Permit to Alter Case Report

Filing Date: August 29, 2012
Case No.: 2012.1123H
Project Address: 1100 Market Street
Category: Category I (Significant) – Renoir Hotel or Hotel Shaw
Zoning: C-3-G (Downtown General)
120-X Height and Bulk District
Block/Lot: 0351/001
Applicant: Daniel Frattin
Reuben & Junius LLP
One Bush Street, 6th floor
San Francisco, CA 94104
Staff Contact: Pilar LaValley - (415) 575-9084
pilar.lavalley@sfgov.org
Reviewed By: Tim Frye - (415) 558-6625
tim.frye@sfgov.org

Historic Preservation Commission Draft Motion Permit to Alter MAJOR ALTERATION

Notice of Planning Department Requirements #1

Roof Floor Plan
Scale: 1/16" = 1'-0"

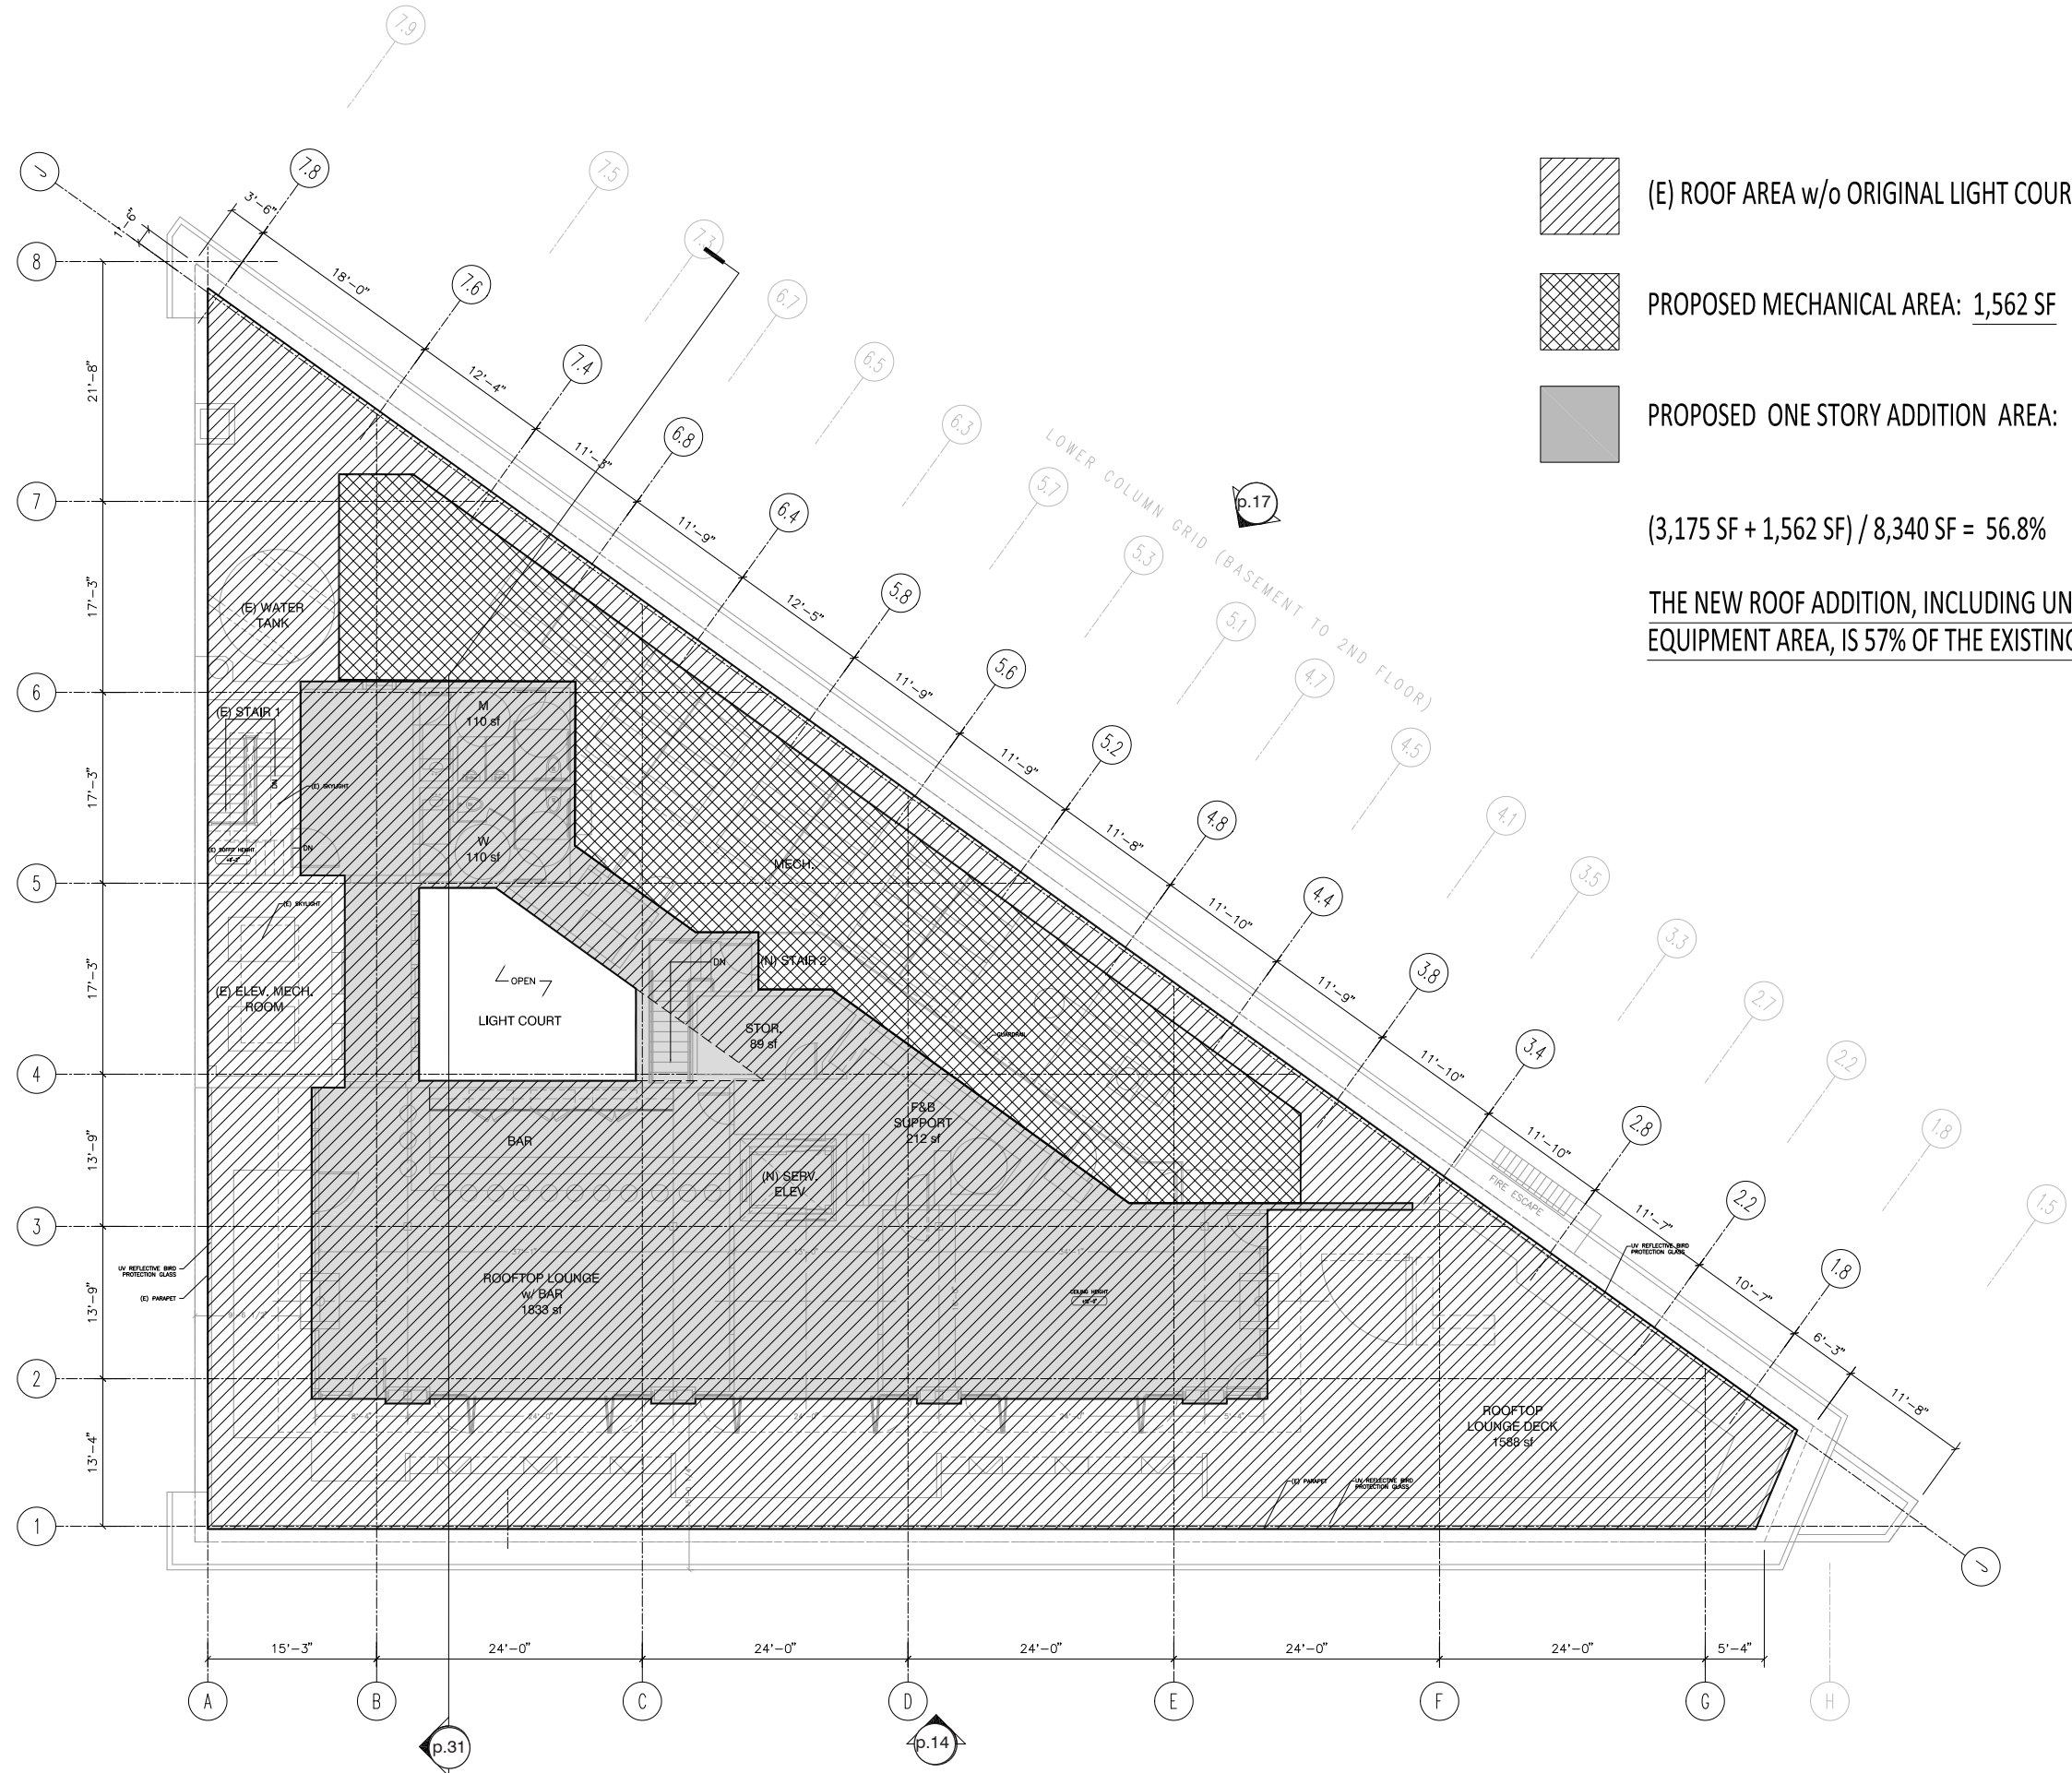
- Addition:** Article 11 limits additions to height of Category I (Significant) buildings (including addition of mechanical equipment) to one story above the height of the existing roof and covering no more than 75 percent of the roof area. Please provide graphics and calculations demonstrating that the proposed addition, including mechanical equipment, will cover less than 75 percent of the roof area.

- a. Please refer to the attached roof area plans and notice that the built addition, including unenclosed mechanical area, is below the 75% maximum limit.

THE NEW ROOF ADDITION, INCLUDING UNENCLOSED MECHANICAL EQUIPMENT AREA, IS 57% OF THE EXISTING ROOF AREA.

Renoir Hotel
Shadow Study
June 20th - 7am

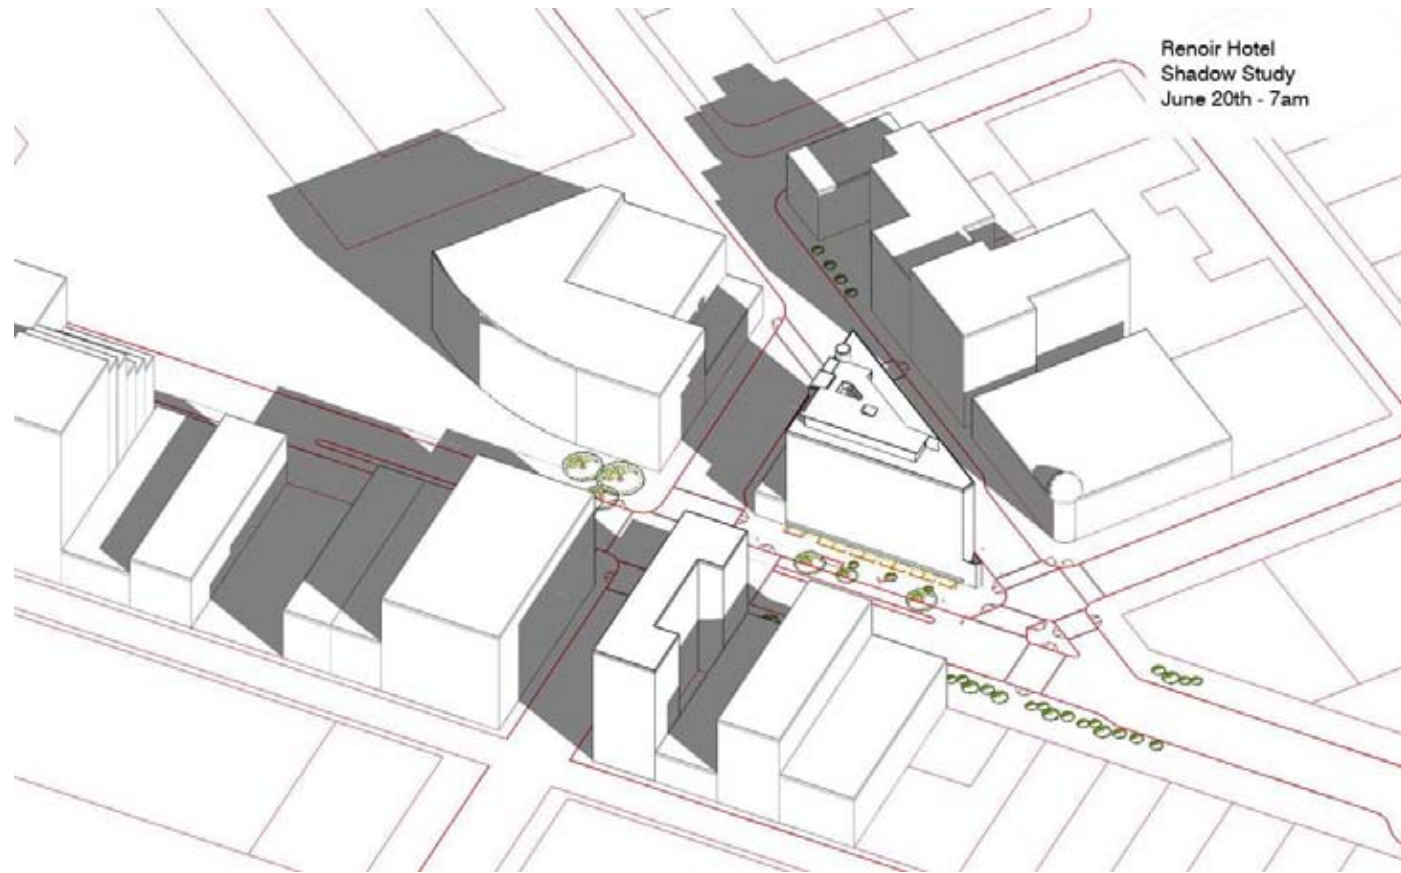
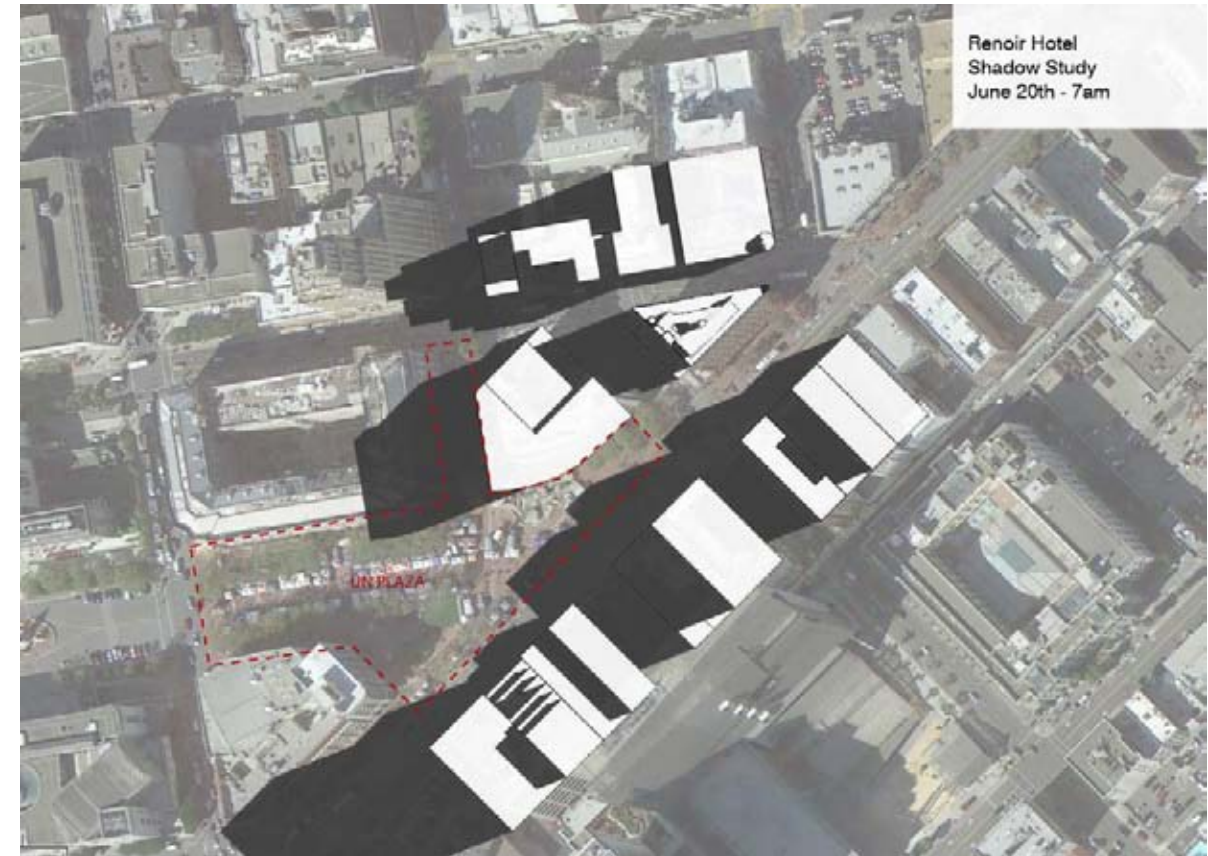
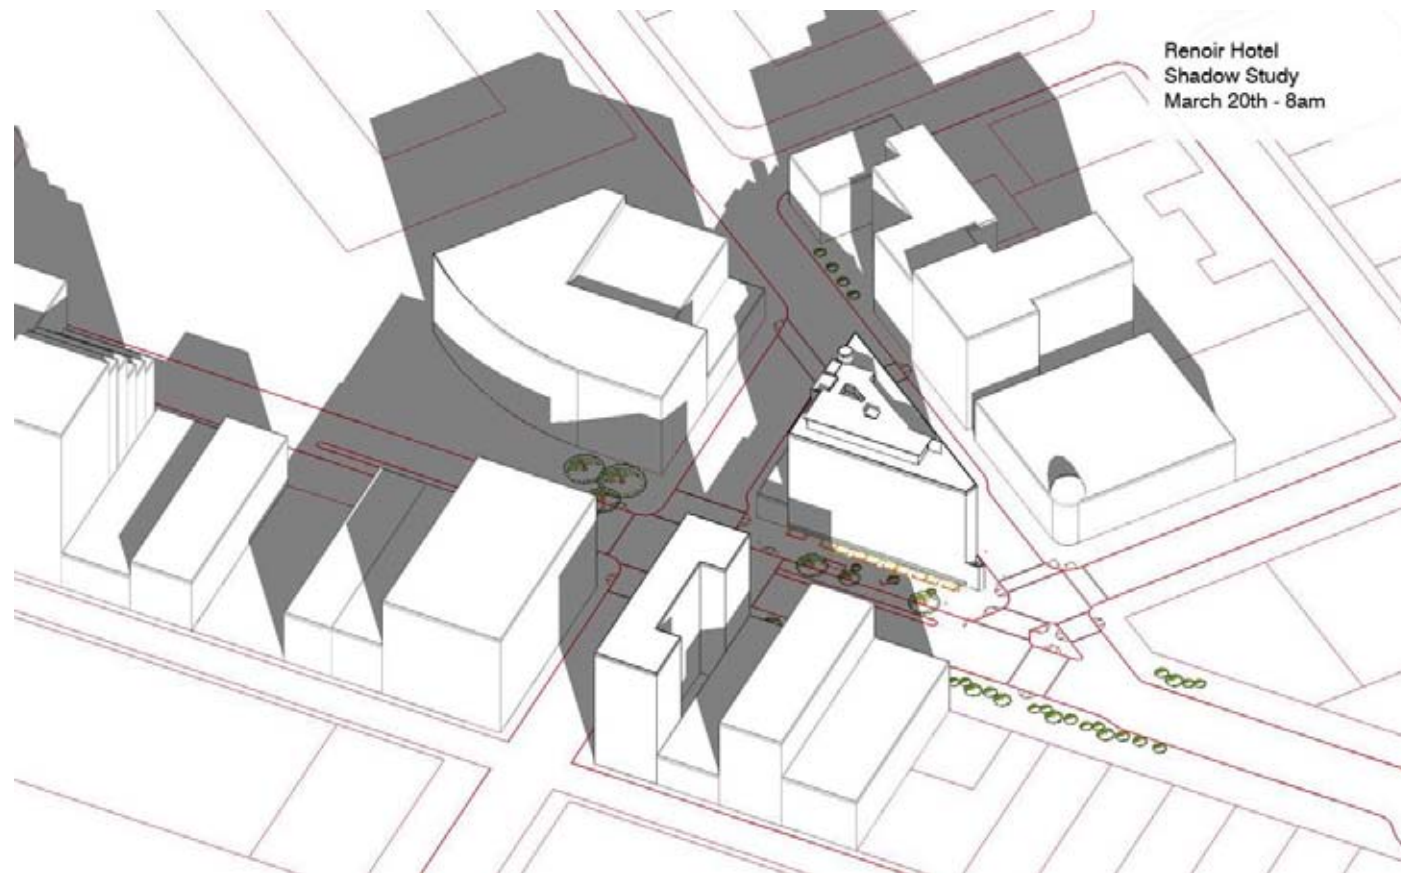
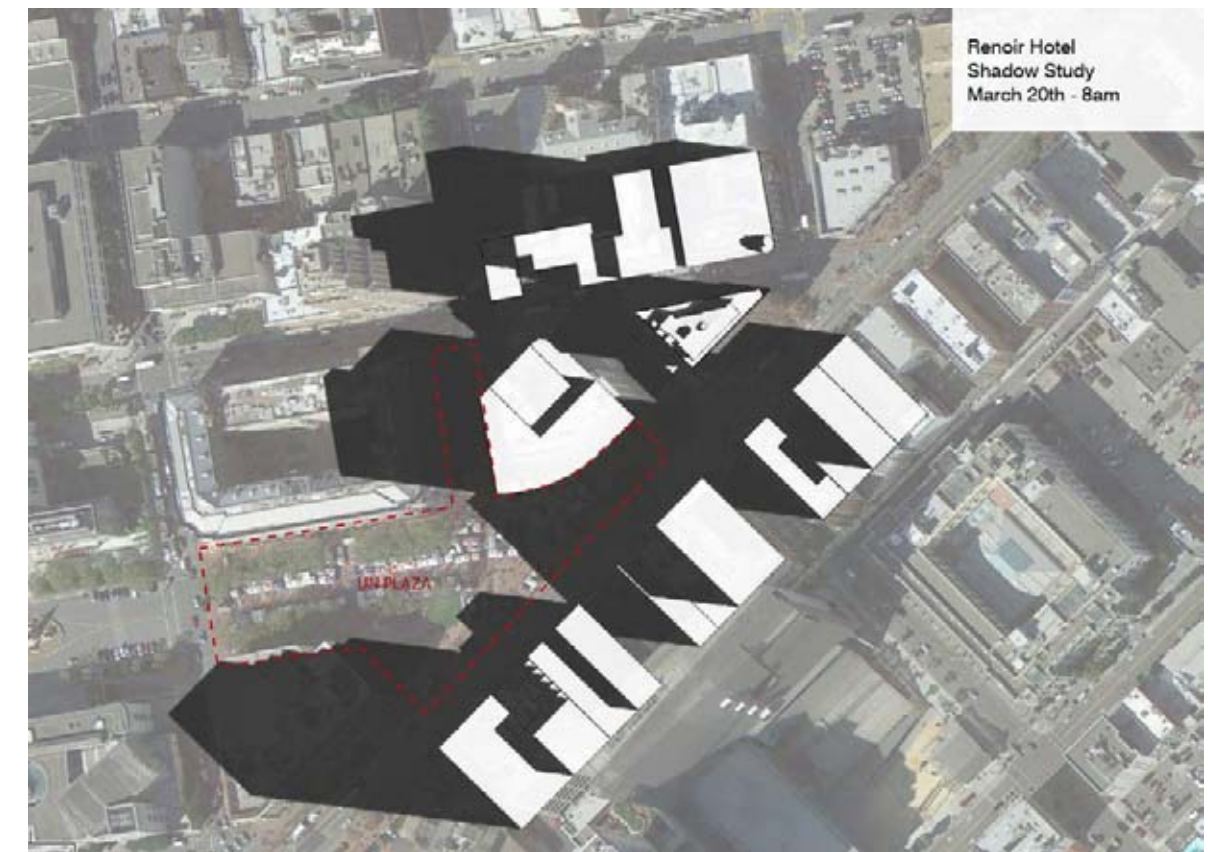
- Shadow:** Planning Code Section 147 encourages that new construction or additions that result in a building height that exceeds 50 feet shall be shaped, consistent with the dictates of good design and without unduly restricting the development potential of the site in question, to reduce substantial shadow impacts on public plazas and other publicly accessible spaces other than those protected under Planning Code Section 295. The initial shadow fan analysis prepared for this project suggests the potential for a small amount of shadow on United Nations Plaza, an open space that is not protected under Planning Code Section 295. Since the fan analysis does not take into account intervening buildings or topography, please provide graphic projections depicting potential shadow at peak times of year towards United Nations Plaza.

- a. Please refer to attached shadow diagrams for impacts at the peak times of year. As the diagrams show, the UN Plaza is not impacted by the building addition's shadow. 1100 Market Street's shadow is blocked by intervening buildings.
- b. To ensure accuracy, the 3D building model was given the exact solar coordinates of 1100 Market St, San Francisco, CA as well as an accurate north orientation.
